Susanne Crowe, 20 Connaught Parade, Phibsborough, D07 DD34

Re: CPO: Blanchardstown Bus Corridor, Case Reference: KA29N.313961

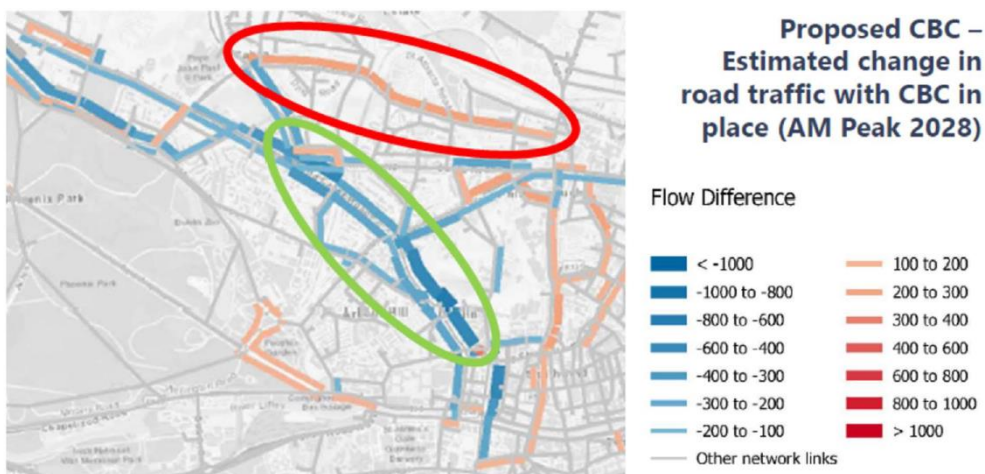
There are three road restriction changes proposed in the CPO application for the Blanchardstown Bus Corridor, none of which were set out in any of the proposed designs issued for public consultation since the Bus Connects project commenced in 2018.

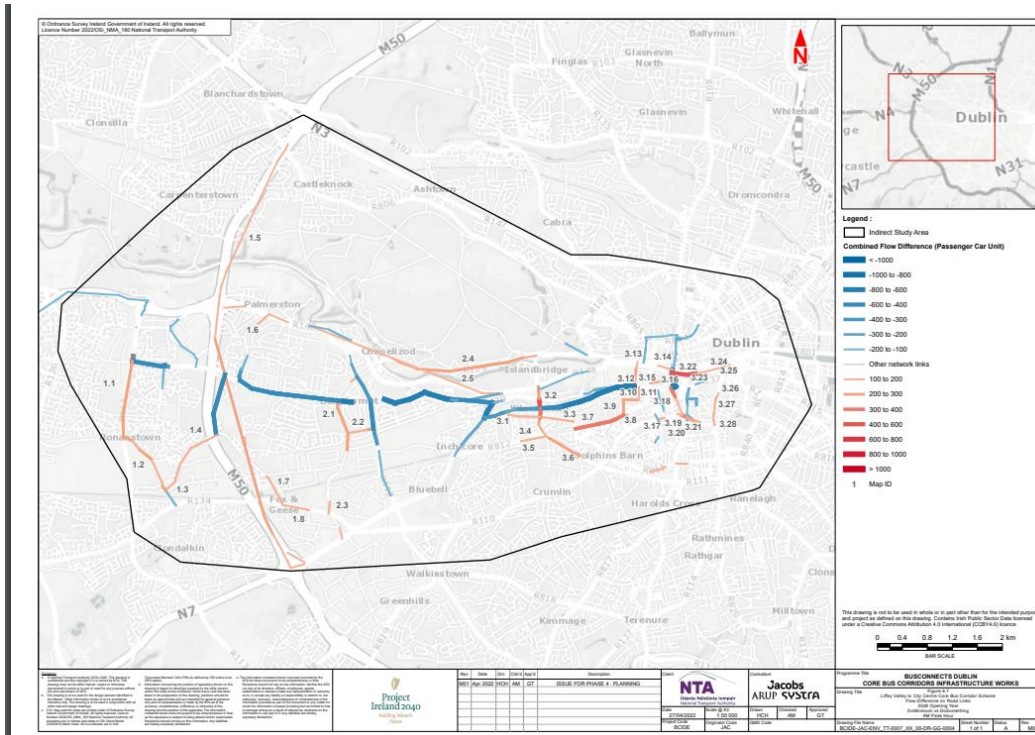
- **Flawed classification system of the impacts which sees areas forecast to experience an 80% increase in traffic flows being described as a “low impact” change.** In appendix A6.4 of the EIAR, Impact Assessments, the following are estimated when comparing a “Do Minimum” with a “Do Something” (i.e., BusConnects) scenario at PM peak hour:

- An 80% increase in hourly traffic flows at the junction of Connaught Street and Shandon Crescent,
- A 55% increase in hourly traffic flows at the junction of Fassaugh Ave and Dingle Road,
- A 64% increase in hourly traffic flows at the junction of Fassaugh Ave and Bannow Road.

Each is described as having “not significant” effect and “negligible” impact. I can tell you as a resident of Connaught Street there is no way that changes of this nature can be considered “not significant” and “negligible” in their impacts on our abilities to go about our daily lives and live in a safe environment!
